Plan Commission

Agenda

Monday, September 28, 2020

SHEET: **C0.1**

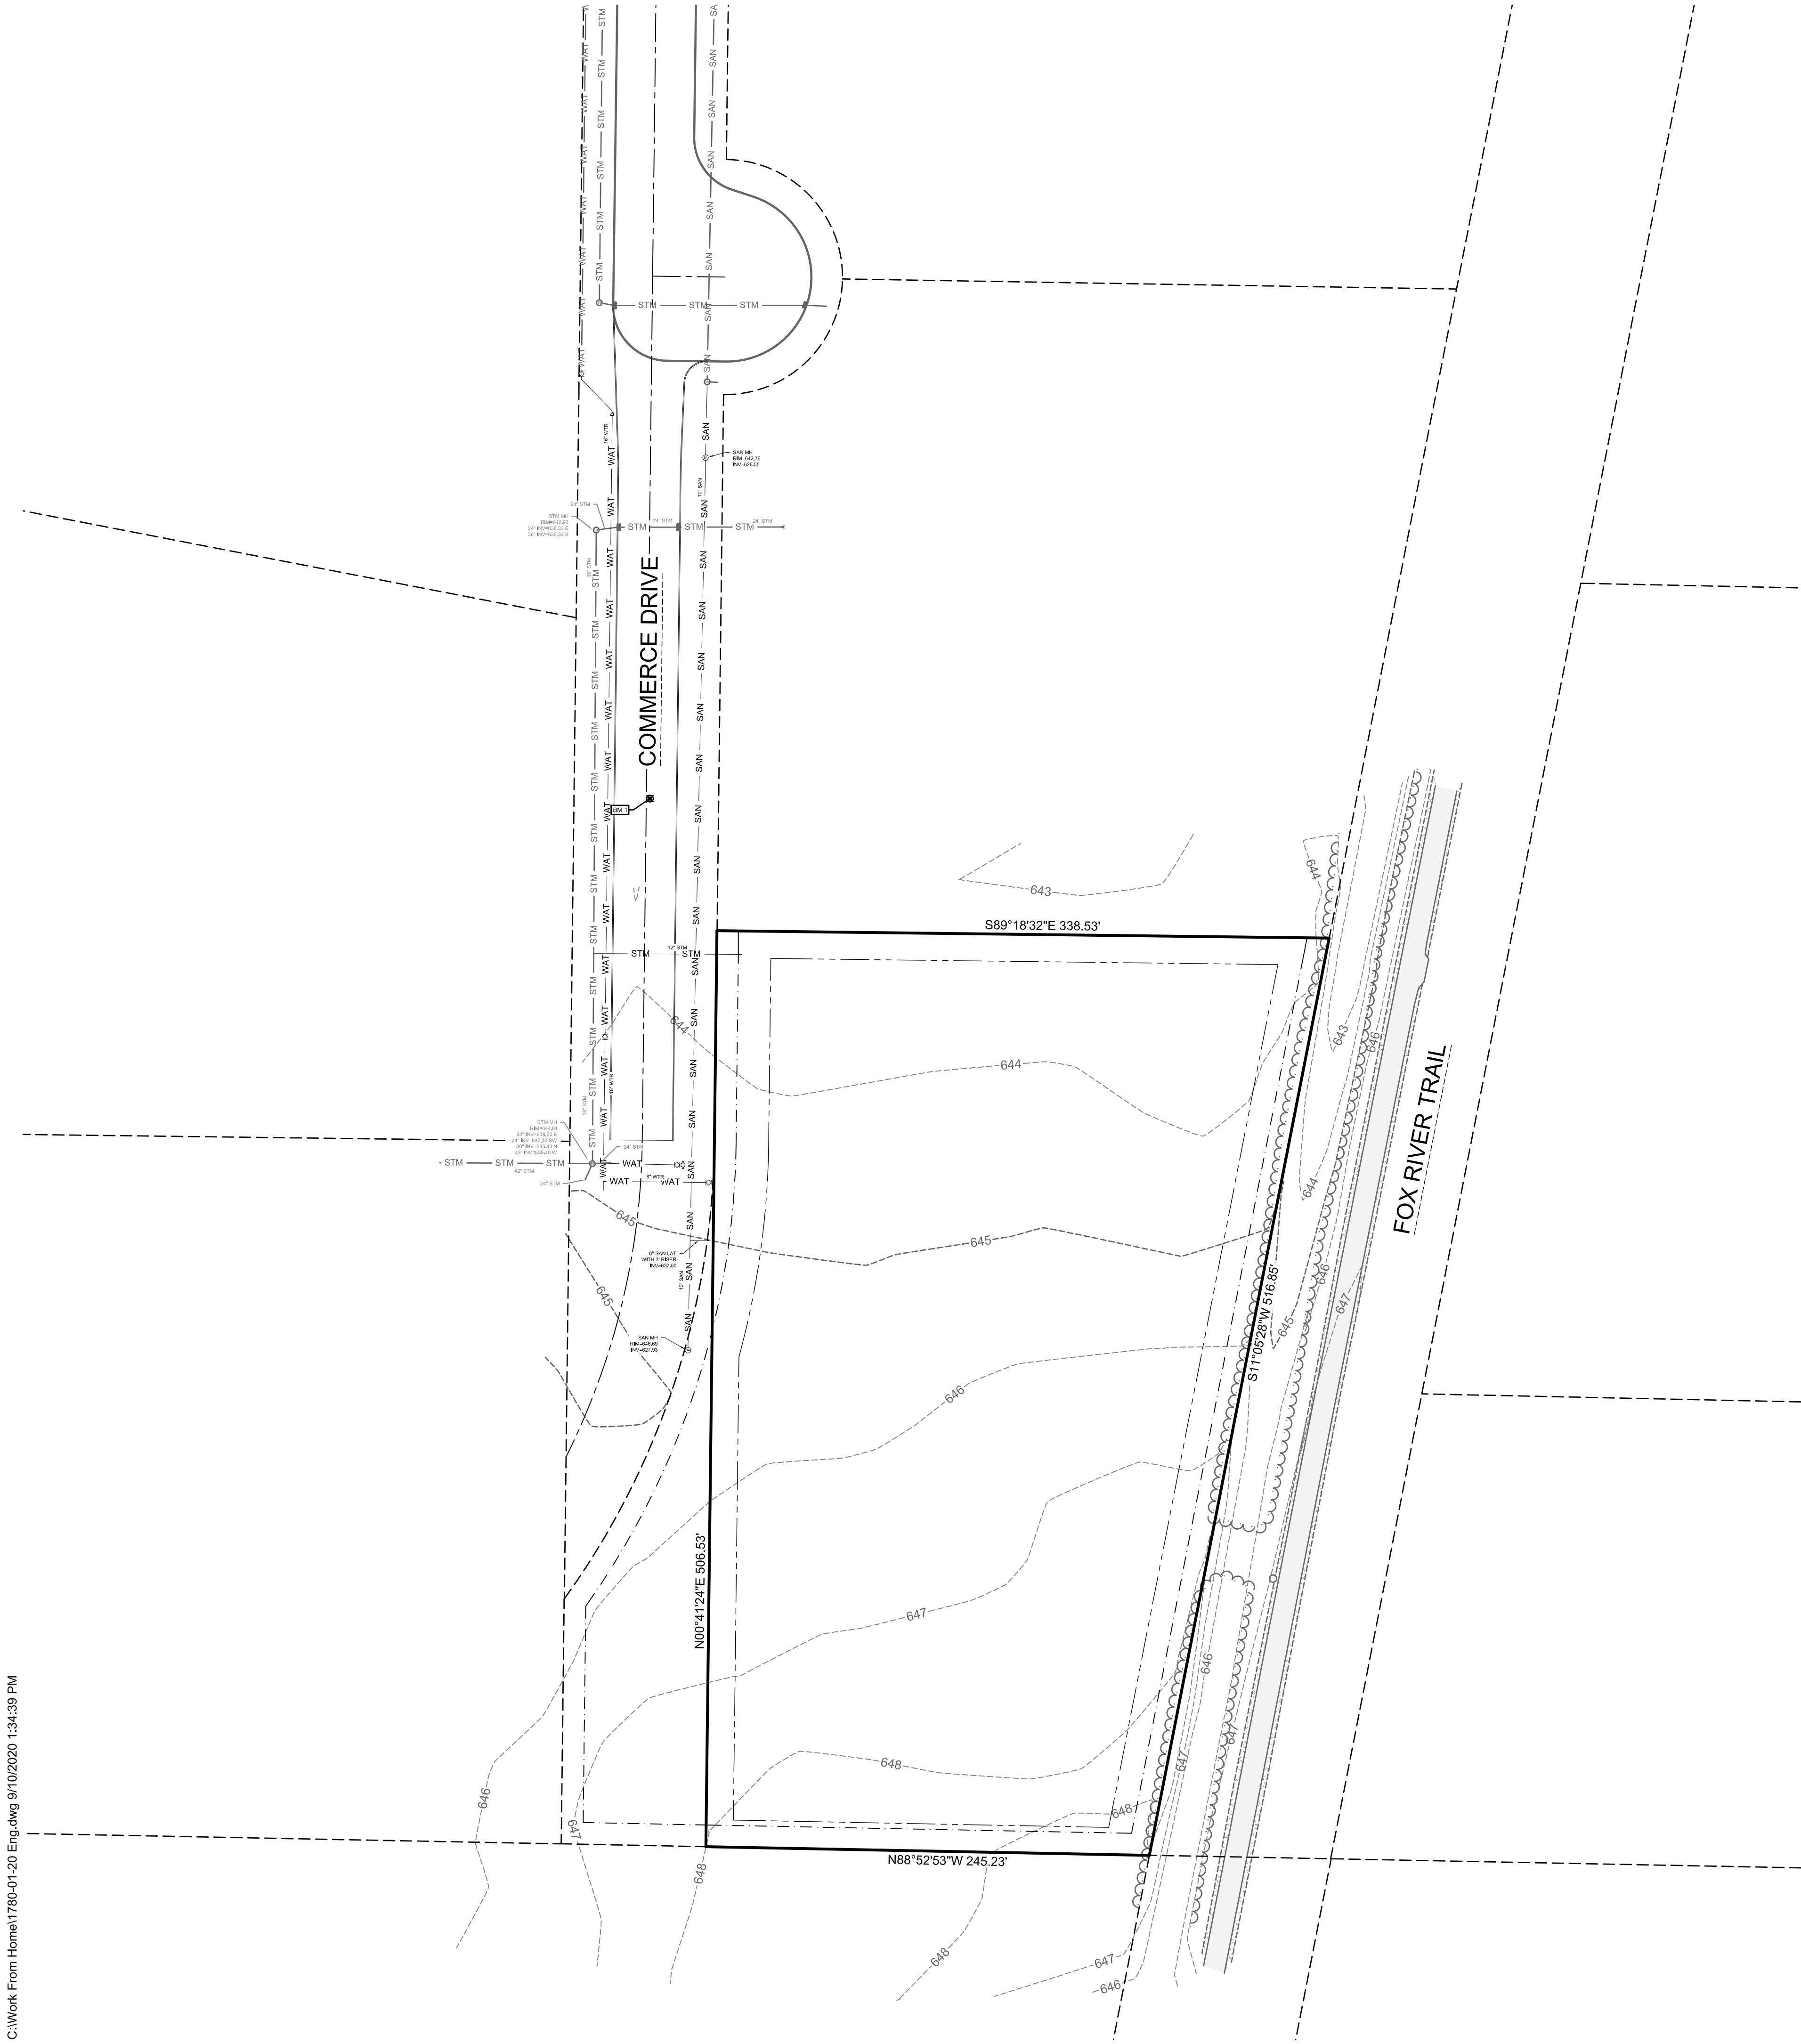
1. On Sheet C0.1:
 - a. Update the legal description.
 - b. Provide owner information.
 - c. Civil General Note 17 should list sheets C5.1 and C5.2 for erosion control plan and notes.

SHEET:
C1.0

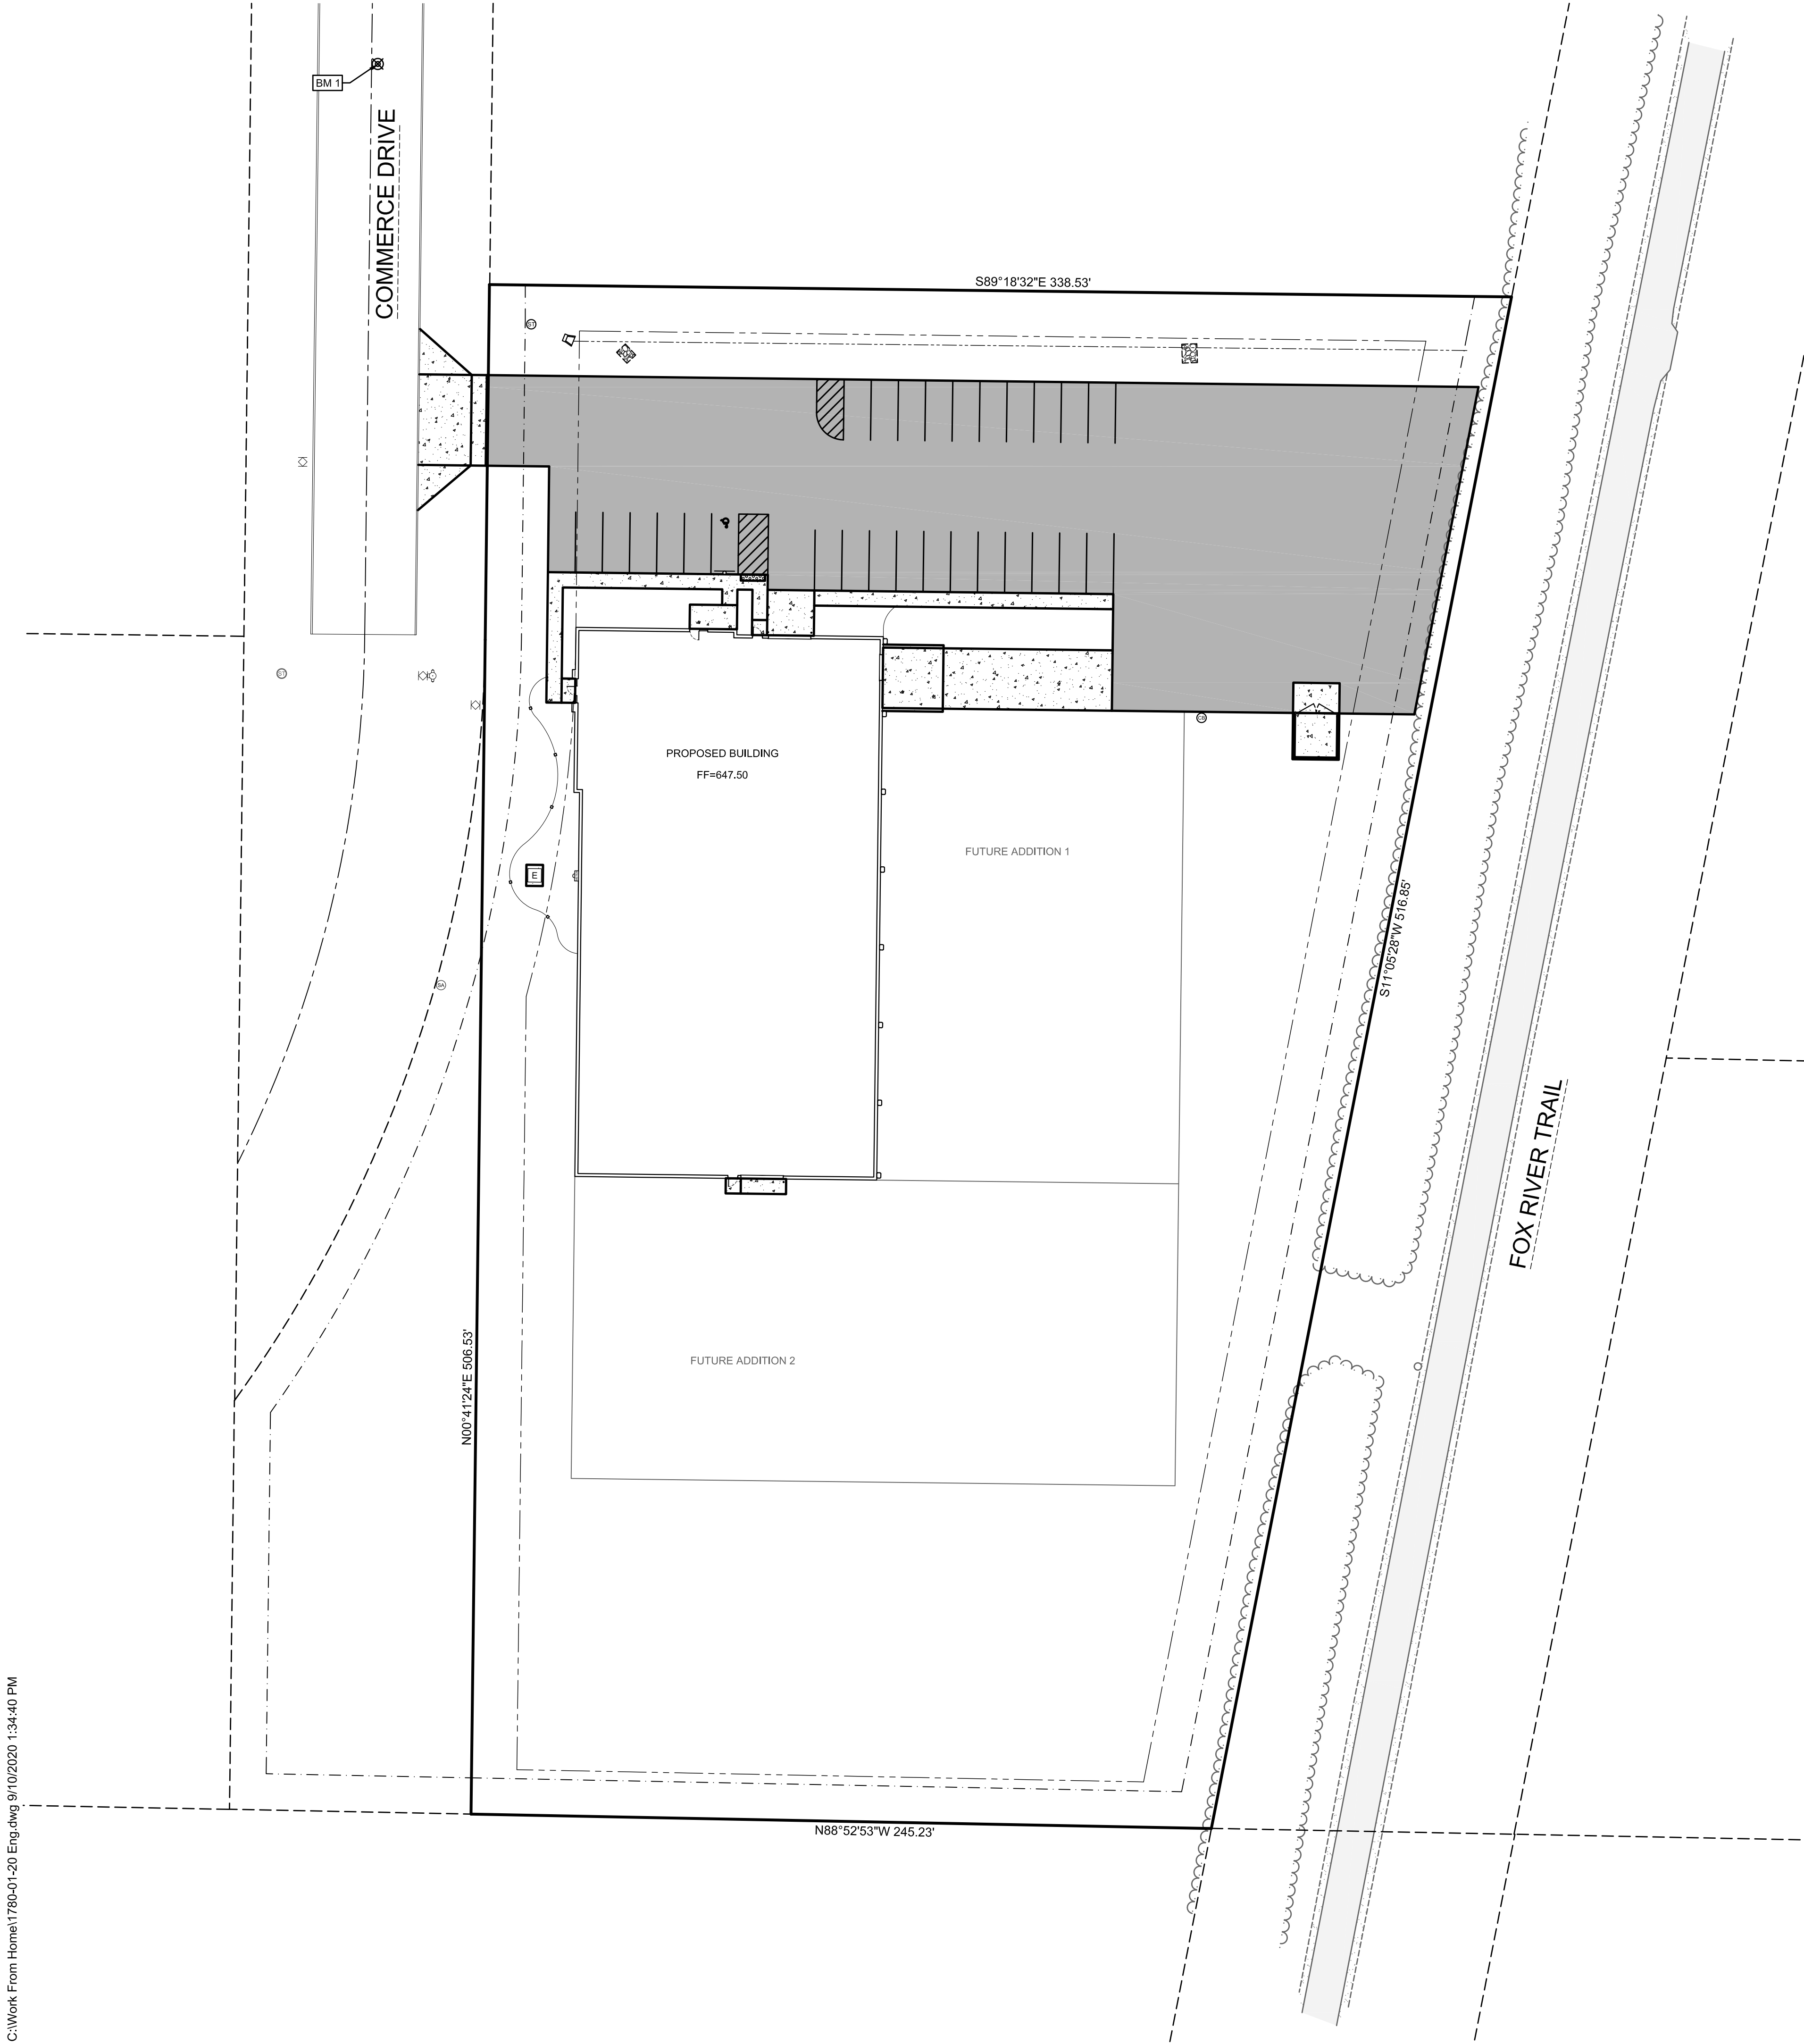
2. On Sheet C1.0:
 - a. Show existing wetlands per the report provided by the City of De Pere.
3. On Sheet C2.0:
 - a. Two (2) ADA stalls are required per ADA standards (two stalls required for the total number of parking spaces between 26 and 50).

UTILITY PLAN - NORTH

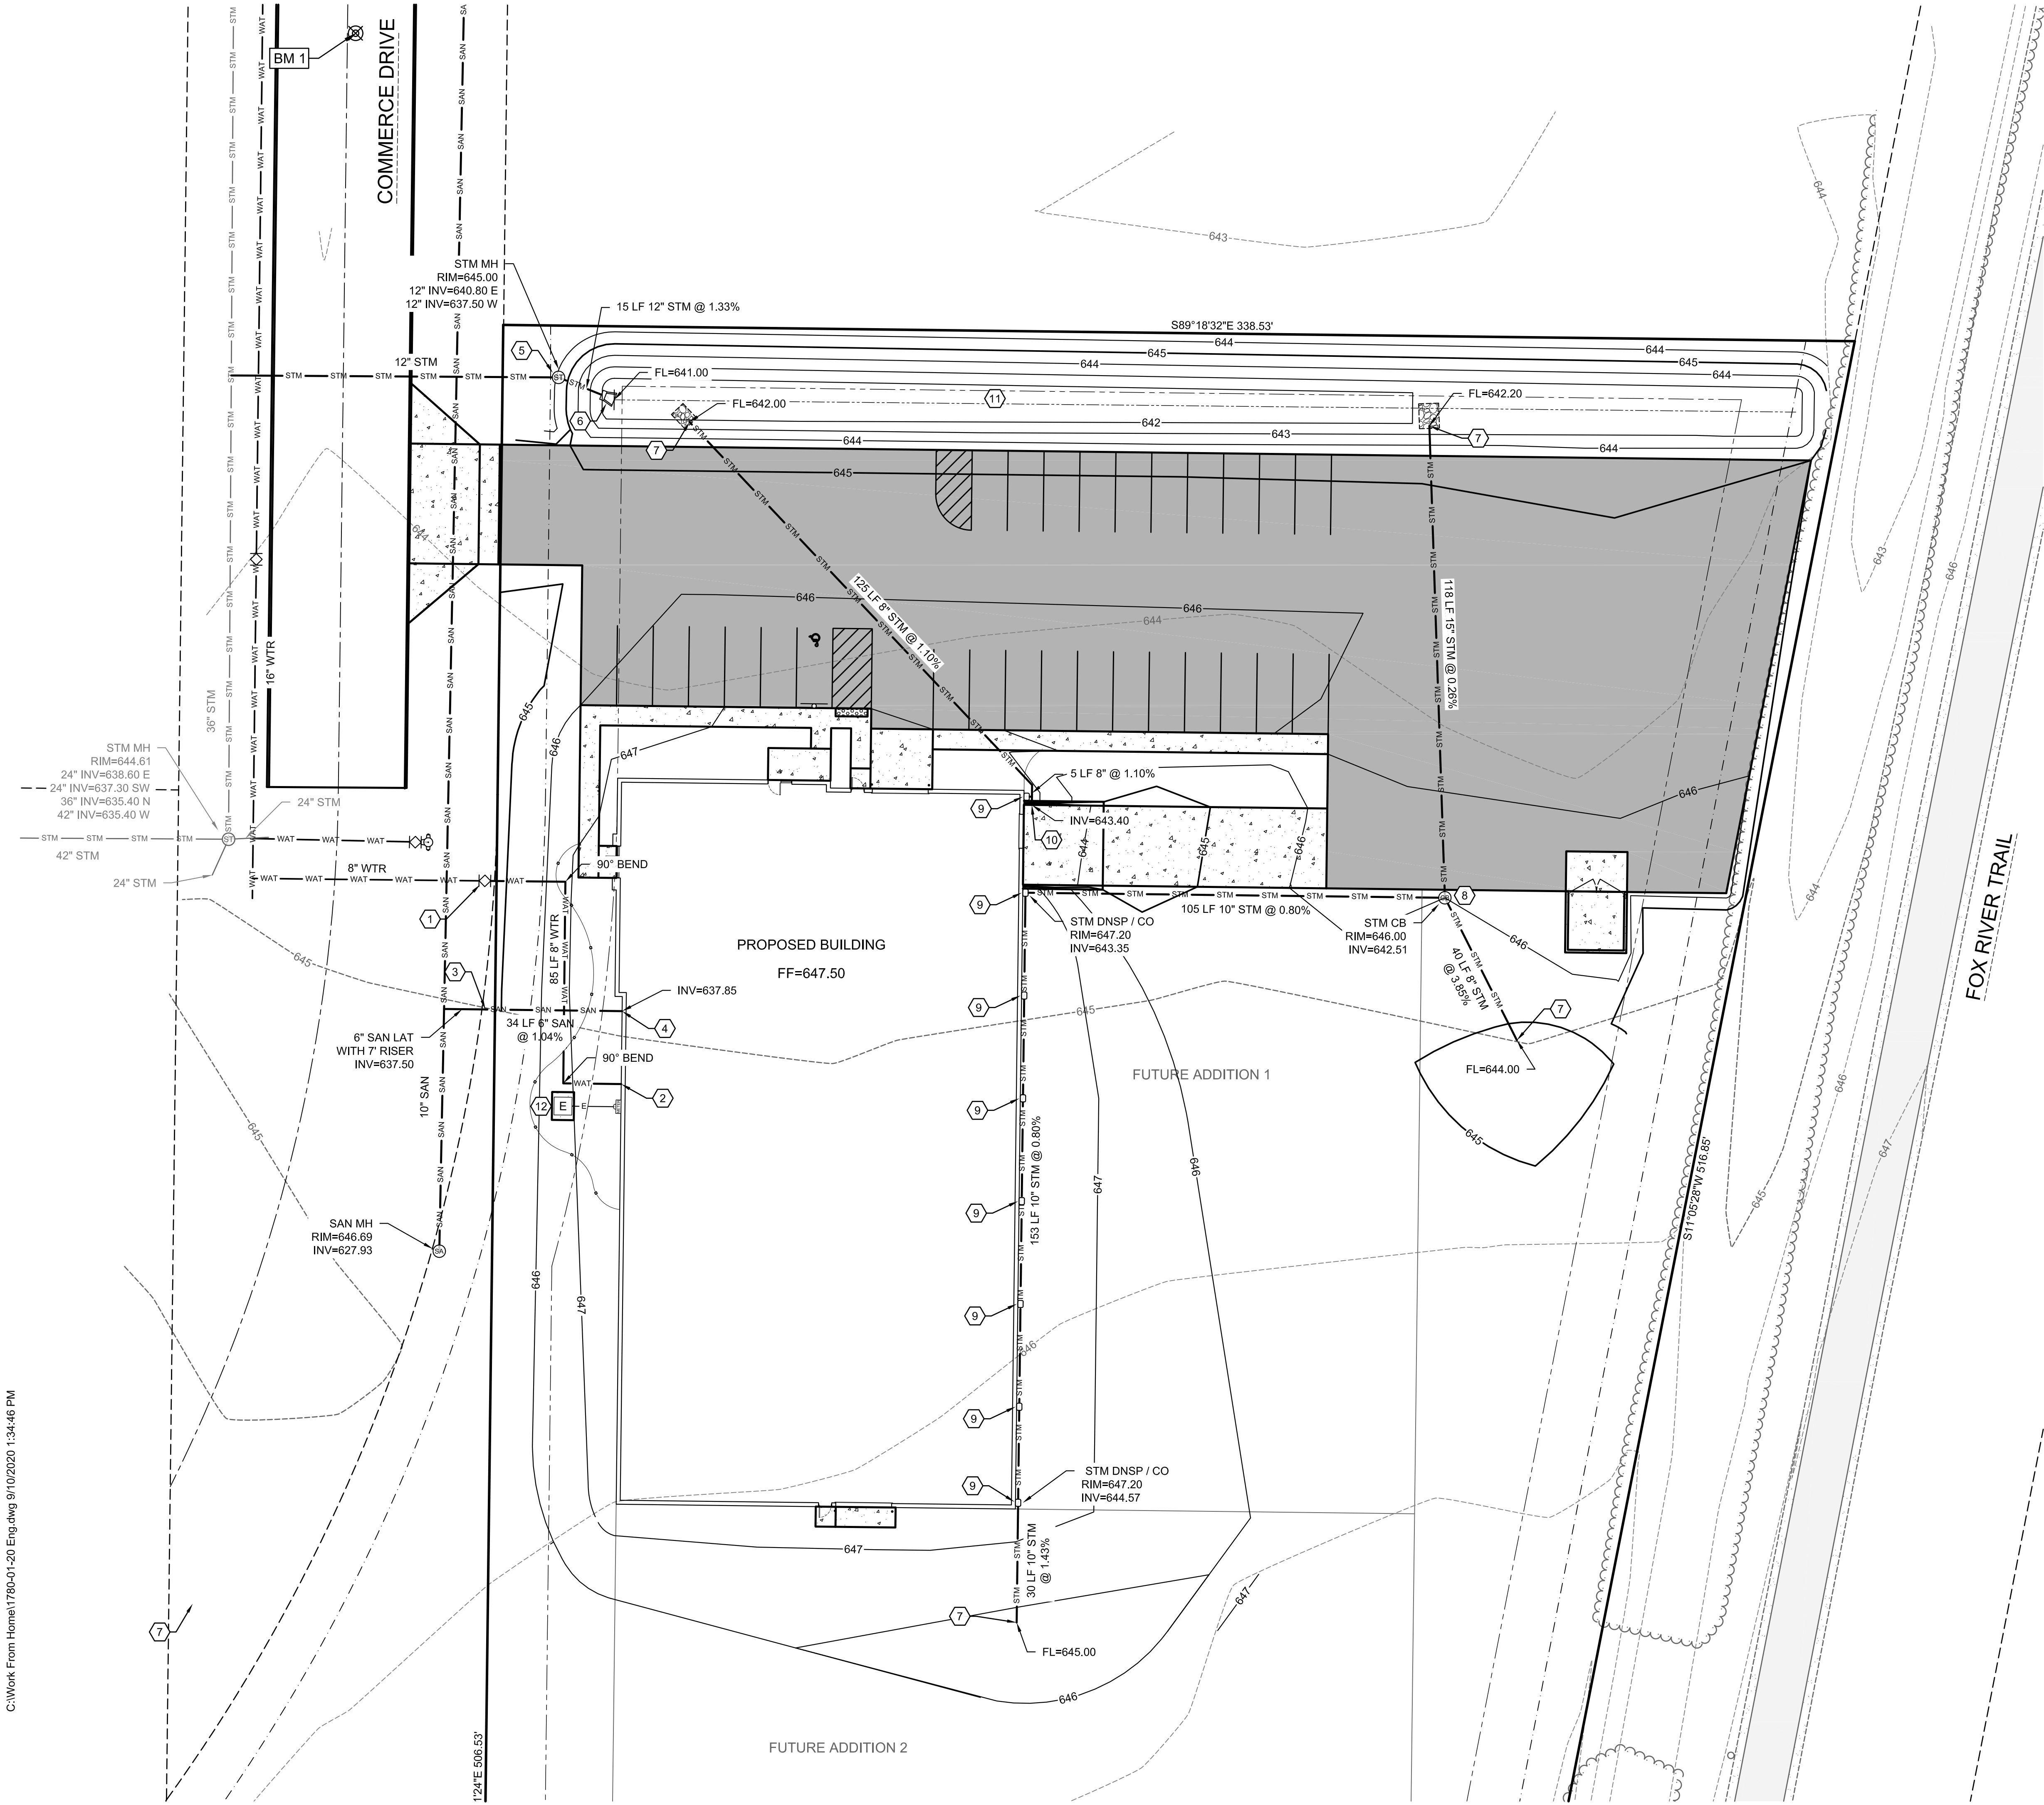
5. On Sheet C3.1:
 - a. This is the only utility plan. The sheet title does not need to be labeled "north". Naming the sheet north implies there are additional sheets.
